ADDENDUM NO. 002

RE: Bristol Community Health Center, Phase I Renovations
For Southwest Virginia Community Health Systems
T&L Project No. 16493

DATE: April 4, 2023

E FIRST FLOOR LOBBY ENLARGED PLAN
 SCALE: 1/4" = 1'-0"

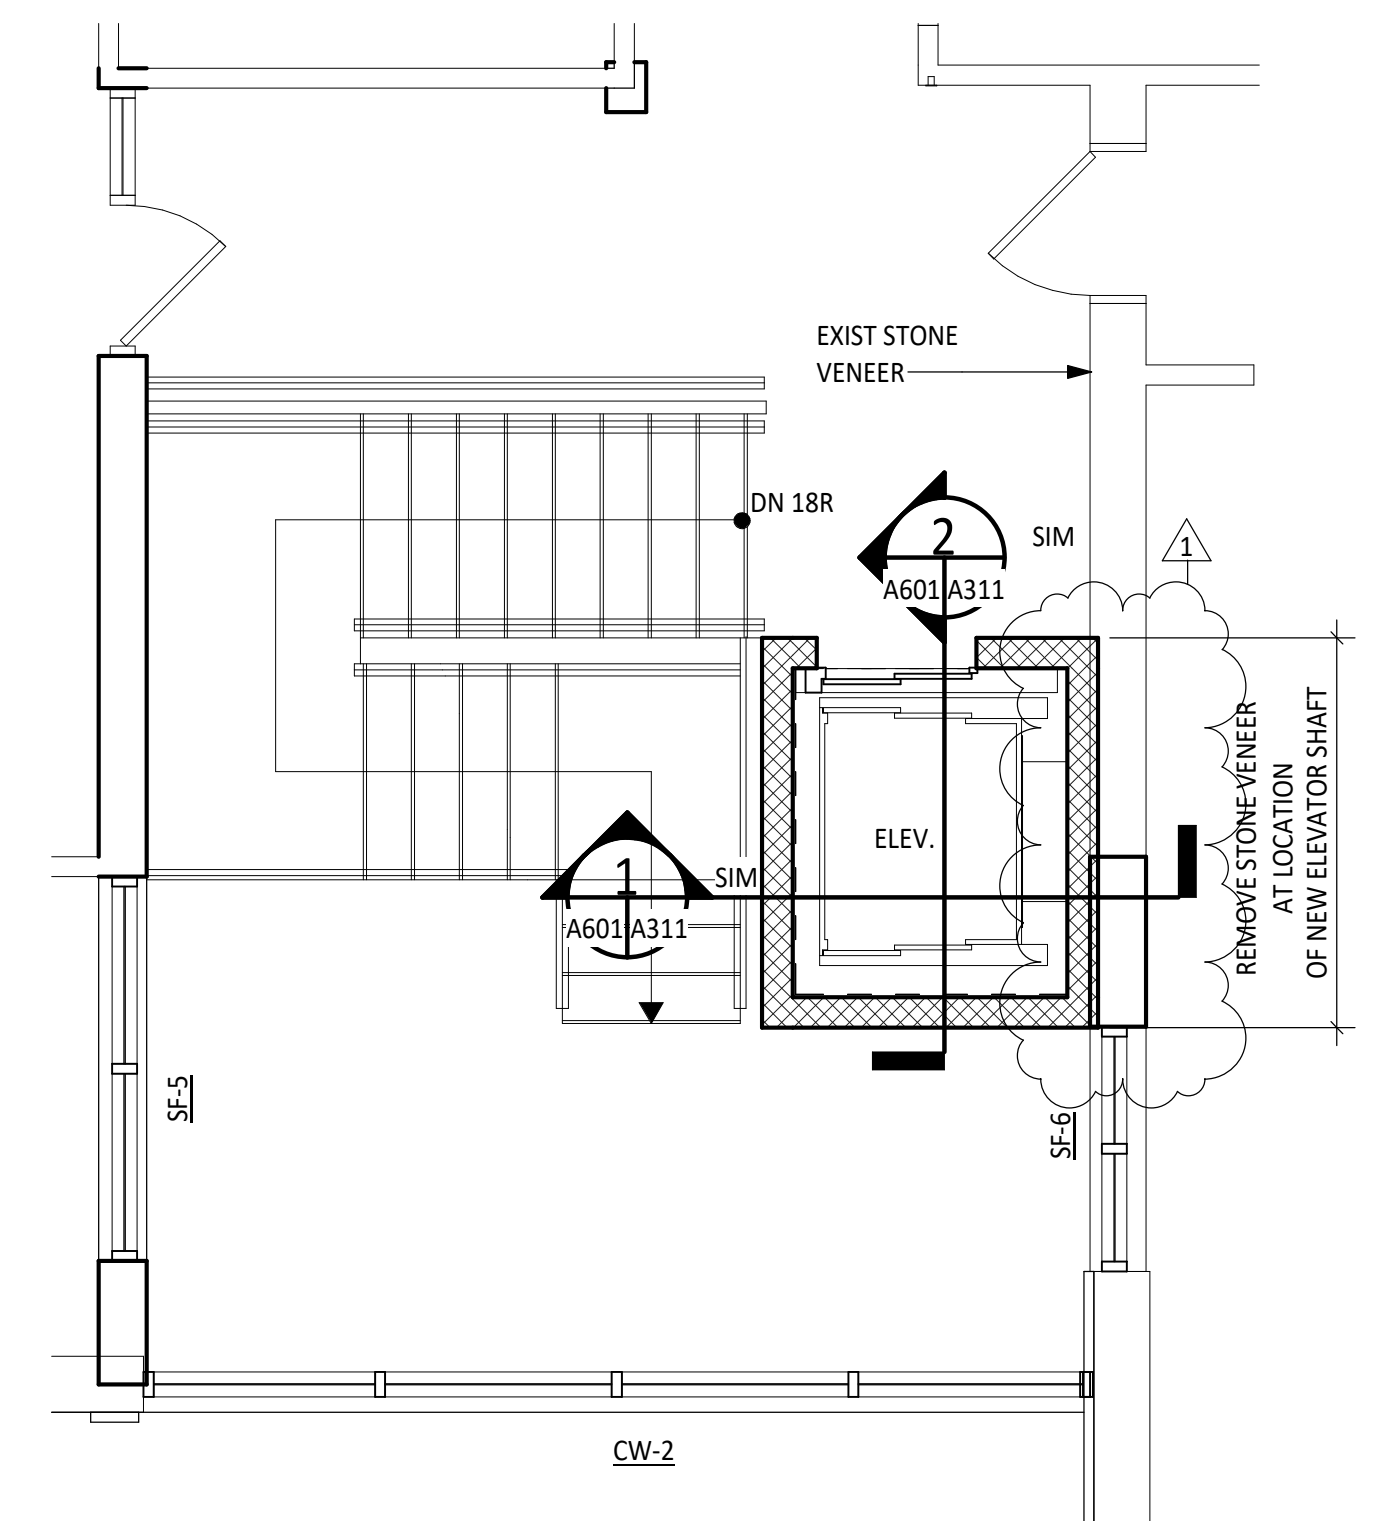
4. Refer to Drawing A103 for revisions to reflected ceiling at relocated elevator Machine Room 161 and Vestibule 162.
5. Refer to Drawing A601 for revisions and clarifications at elevator and machine room.
6. Refer to Drawing A201 for revised number and spacing of Aluminum Storefront Elevation (SF-4) and locations of wall cap WC-1, and louvers L-1 & L-2.
7. Refer to Drawing A701. Add new note no. 9 to General Partition Notes that reads, "Provide new 2-1/2" metal Z-furring at Partition Type A0.
8. Refer to Drawing A713 for revised Aluminum Storefront Elevation (SF-4).
9. Refer to Drawing S001 for "Typical Detail – Slab Replacement @ Utility Trench" and "Typical Detail – New Window Opening Existing Exterior Wall".
10. Refer to Drawing S100 for revised elevator shaft plan revisions.

Sheet No.
S100

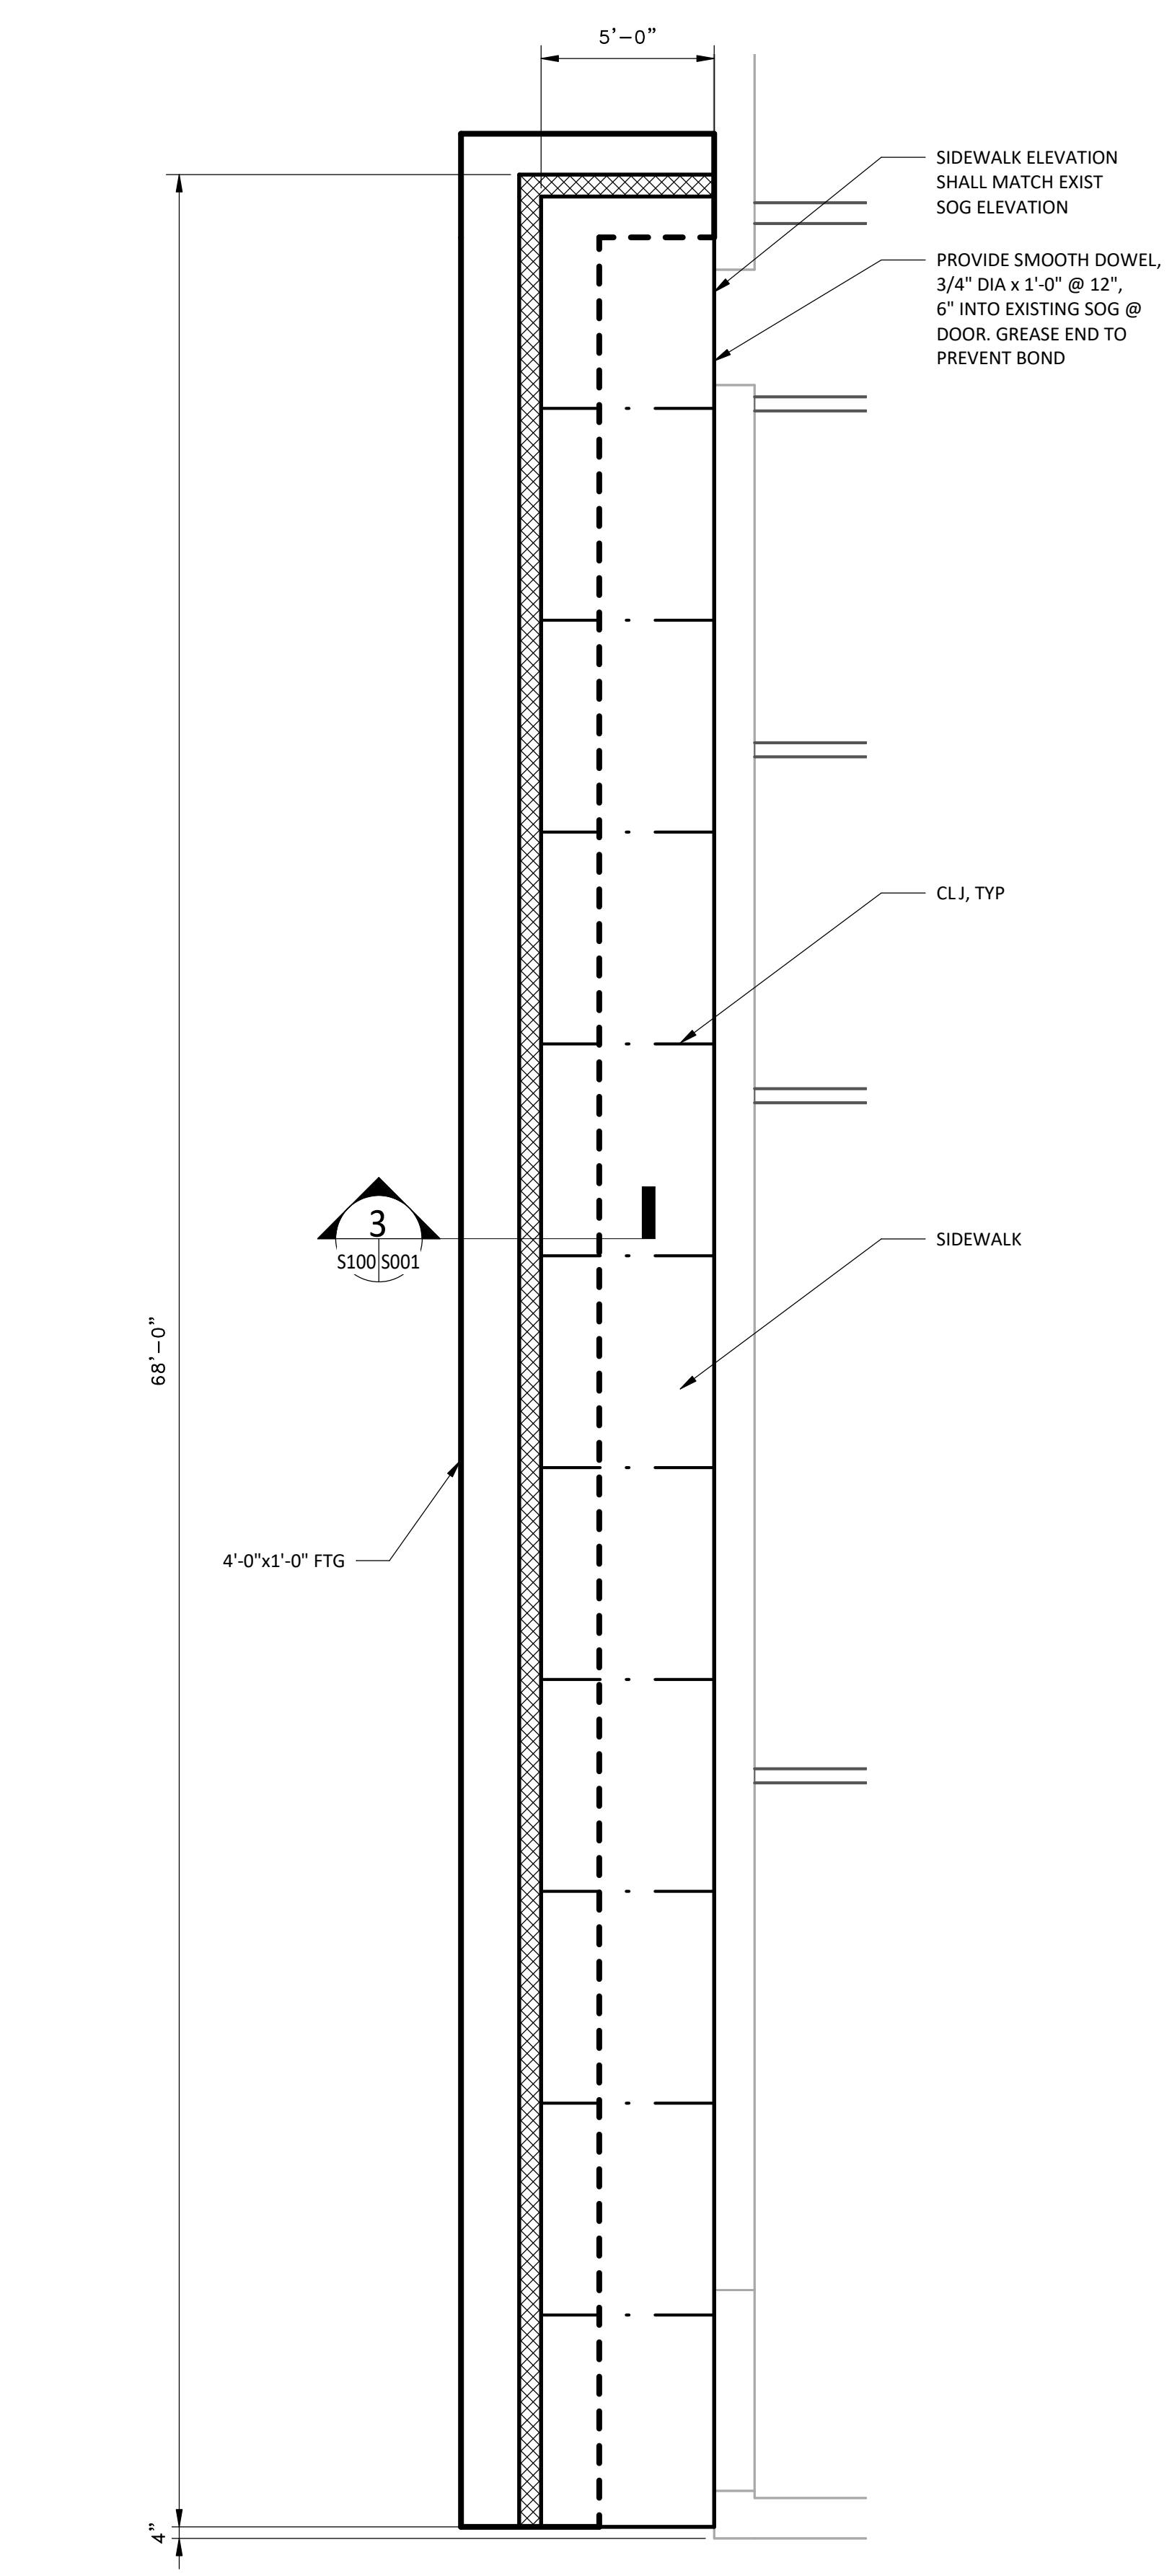
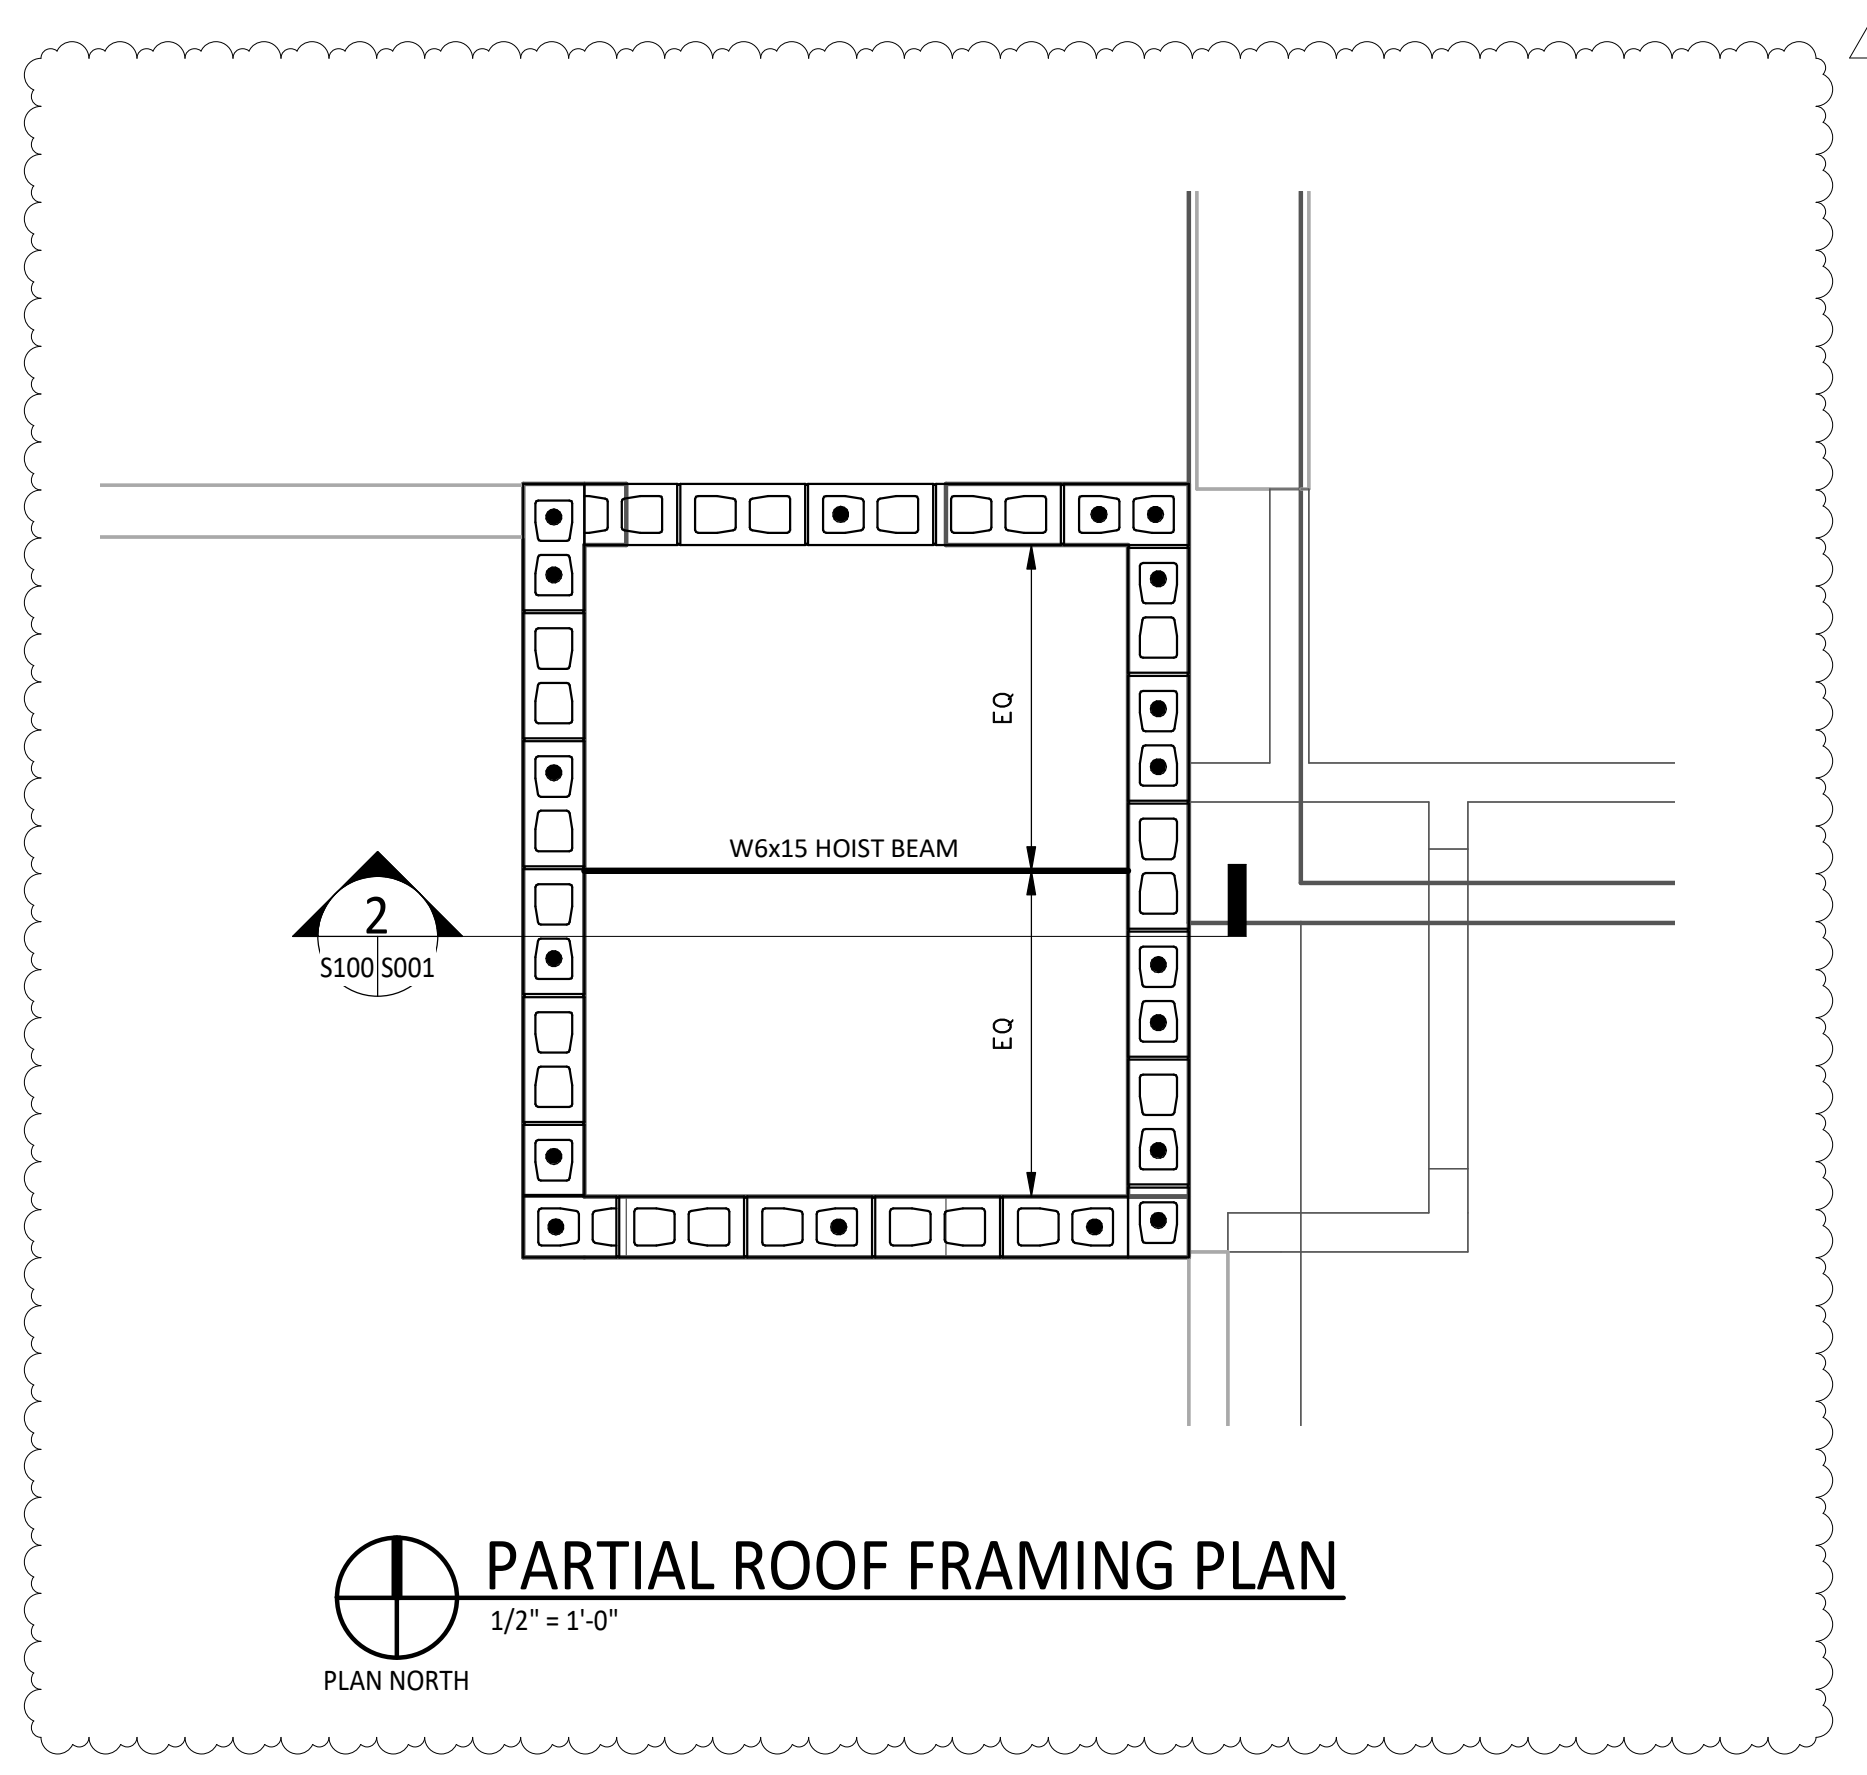
1. The elevator shaft foundation may be reduced to the out-to-out dimension in the plan east-west direction. Keep the foundation extension in the plan north-south direction. Refer to revised Structural drawings.
2. Refer to Sketches ASK-07 thru ASK-09 for details associated with Aluminum Storefront Elevation (SF-4) located in existing exterior wall. Coordinate these sketches with revisions noted below and on enclosed Structural drawing S001.
